Report to the Advisory Committee of Experts for Nuclear Pressure Equipment

ASN Report reference CODEP-DEP-2017-019368

Session of 26 and 27 June 2017

**Analysis of the consequences of the anomaly in the
Flamanville EPR reactor pressure vessel head domes
on their serviceability**

Figure 7: Areas not inspected on the upper dome of the Flamanville EPR reactor pressure vessel with regard to the search for under-cladding flaws

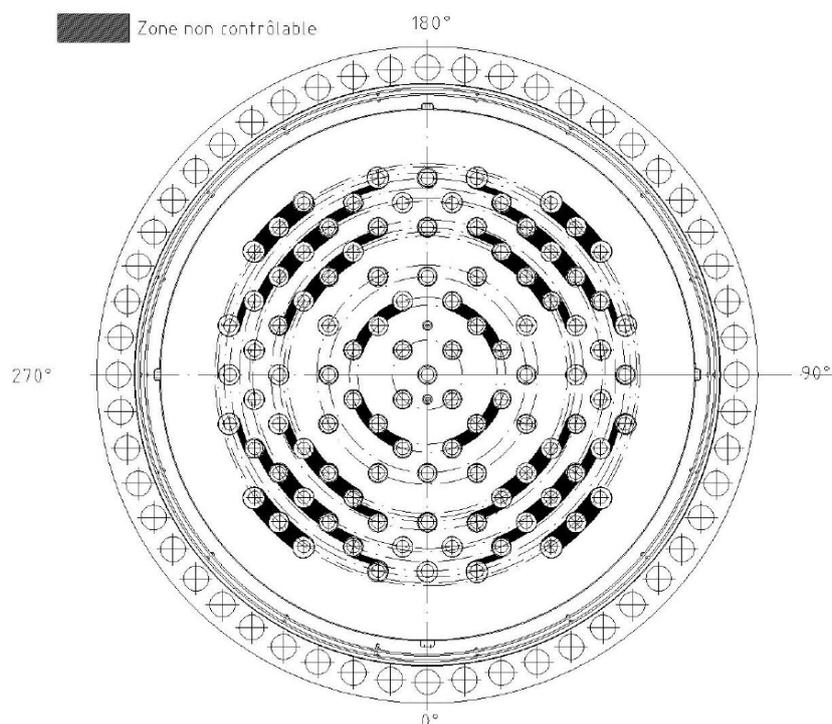
With regard to the upper dome, the entire surface could not be inspected. The inspected zone corresponds to 92% of the cladding of the dome. The remaining 8% corresponds to the inaccessible zones defined in Figure 7. The entire centre of the dome, over a diameter greater than 1.2 m was thus inspected, which covers the potentially segregated zone.

Figure 41: Evolution of reference temperature T_0 versus the carbon content taken from the rapporteur's analysis of the test programme toughness results

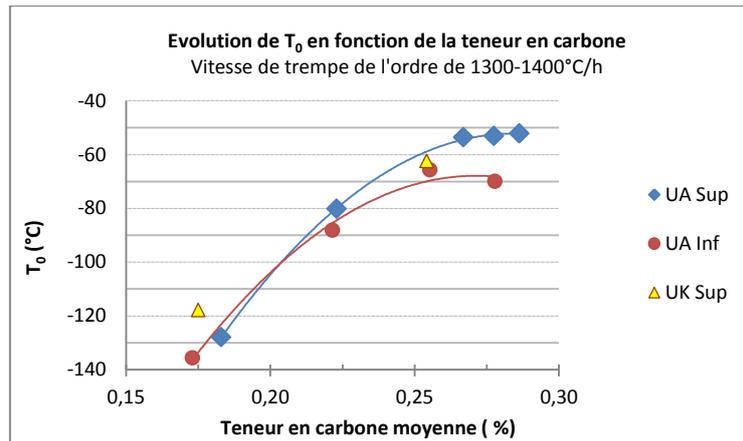
The interpretation of the fracture toughness results made by the rapporteur reaches the same conclusion. At an identical quenching rate, the reference temperature T_0 increases significantly for carbon contents of between 0.18% and 0.25%. The slope of the curve is then inverted for carbon concentrations of 0.25% or higher and the value of T_0 flattens out, reflecting the improved quenchability at carbon contents of between 0.25% and 0.28% (Figure 41).

The rapporteur considers that the RCC-M curve indexed on the optimum temperature or the RT_{NDT} in the segregation zone is able to cover the toughness data of a zone with carbon contents capable of reaching 0.32% on the surface, owing to the more favourable quench effect between one-quarter thickness and the outer surface (Figure 41).

Figure 42: Comparison of the various index temperatures of the RCC-M curve examined in the light of the average carbon content measured on specimen³⁴, at comparable quenching rate (~1300-1400°C/h)

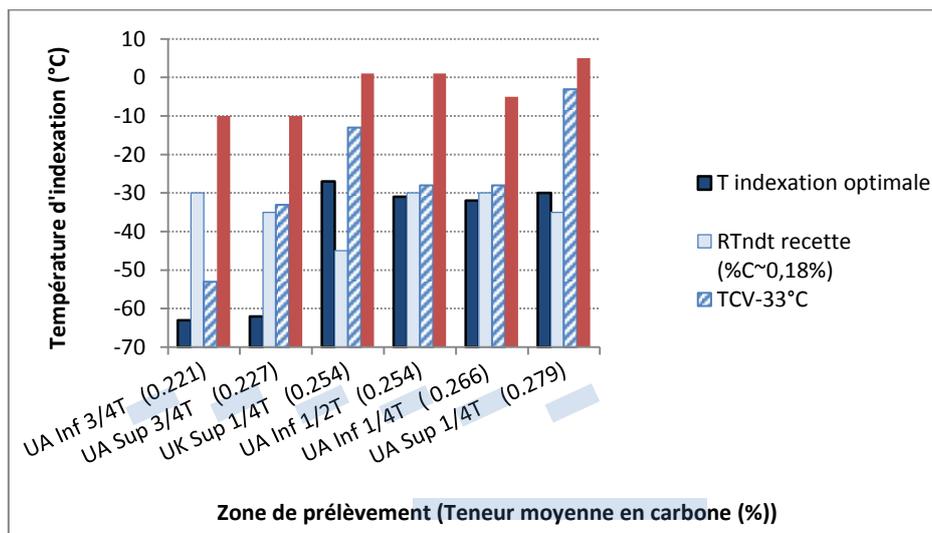
The rapporteur observes that the optimum index temperature of the RCC-M curve is below the temperatures T_{CV-33} and T_{NDT} whatever the depth of the dome at which the samples are taken, as shown in Figure 42. This complies with request n°11³⁵ in the ASN letter in reference [7].

Figure 48: Orientation of flaws sought – dome top view

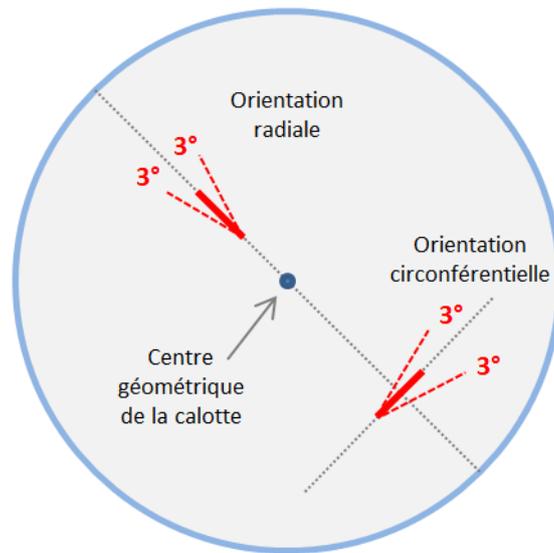
The rapporteur questioned EDF on its ability to detect a flaw that is slightly disoriented with respect to the radial and circumferential directions. At this stage, EDF considers that in the outer part, given the ultrasound path, only flaws disoriented by less than 3° would be detectable (see Figure 48). The rapporteur thus notes that the inspections proposed by EDF will only be able to detect flaws oriented along two angular beams of 6°, or less than 7% of the possible orientations of flaws perpendicular to the outer surface, which would not constitute a significant reinforcement in the second level of defence in depth.

Figure 49: Central part of the Flamanville EPR reactor pressure vessel seen from above – zone to be examined and positions of flaws looked for

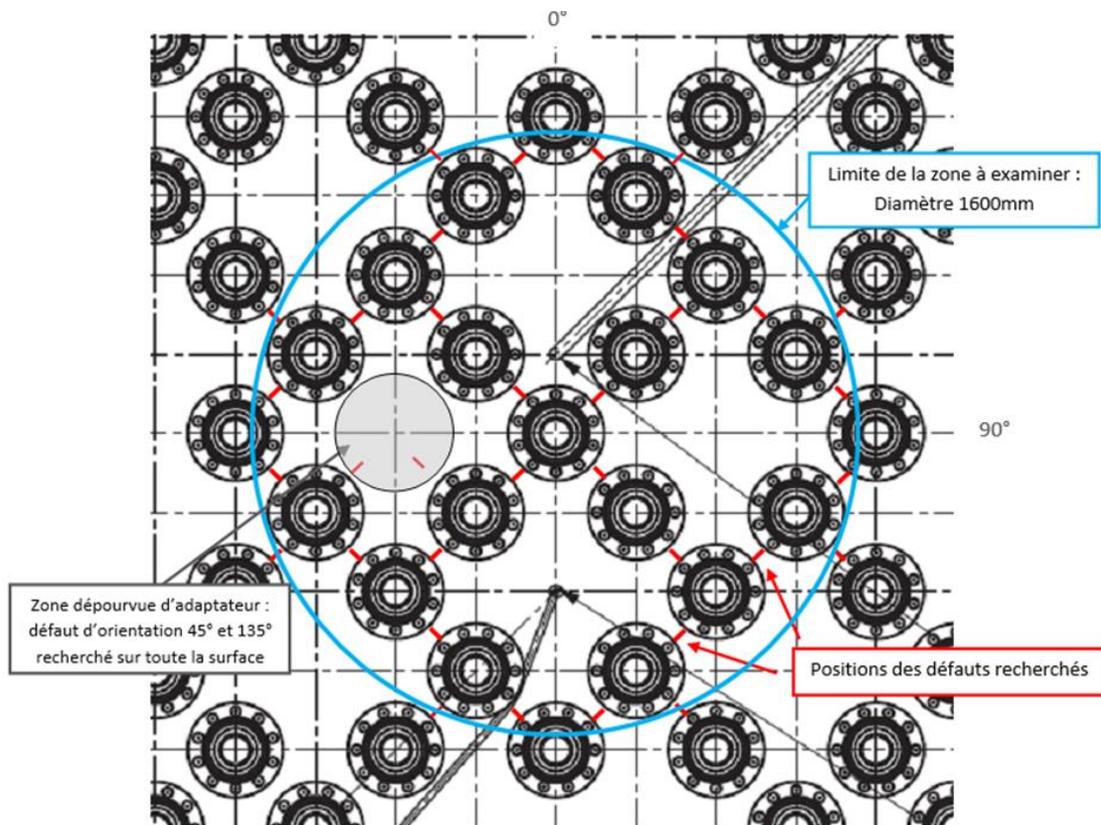
The rapporteur notes that the inspections to which EDF is committed cover a more restricted zone for the closure head than for the bottom head, more specifically because of the search zone limited to the shortest ligaments between adapters (Figure 49) and the impossibility of detecting all the flaws in the vicinity of the adapters (50% at nozzle corner, 80% in continuous part, see Figure 50). The rapporteur also notes that, as with the bottom head, only faults disoriented by less than 3° with respect to the search direction would be detectable. These restrictions imply that the proportion of flaws perpendicular to the surface and detectable in the outer first twenty millimetres is very small.
